INDEPENDENT URBAN DESIGN ADVICE

PROPOSED DEVELOPMENT AT ALPHINGTON PAPER MILL ARTISAN PRECINCT STAGE 2 – ARTISAN WEST

April 2020

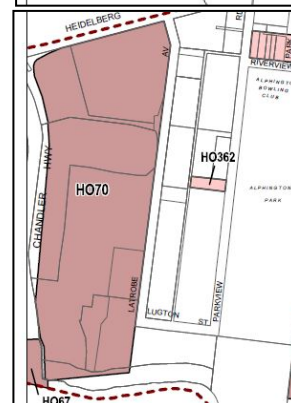
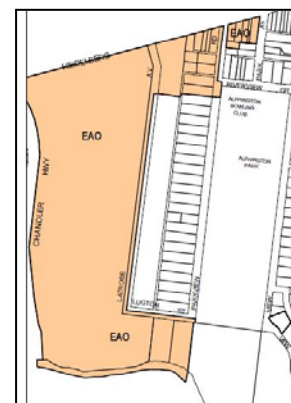
50. Figure 2 describes the preferred heights for the project.

51. The area adjoining the Artisan West Precinct has a preferred height of 14 levels with the approved development some 20-25% greater in height.
52. The two projects sit within Area B where a preferred height of 5 levels is noted with the additional guidance that, "Buildings along major roads to be generally of medium height as appropriate, stepping down to a lower height along the Yarra River interface and Parkview Road"
53. Of relevance to this application it notes the following built form guidance:-
 - a) Built form and articulation should avoid long and continuous facades;
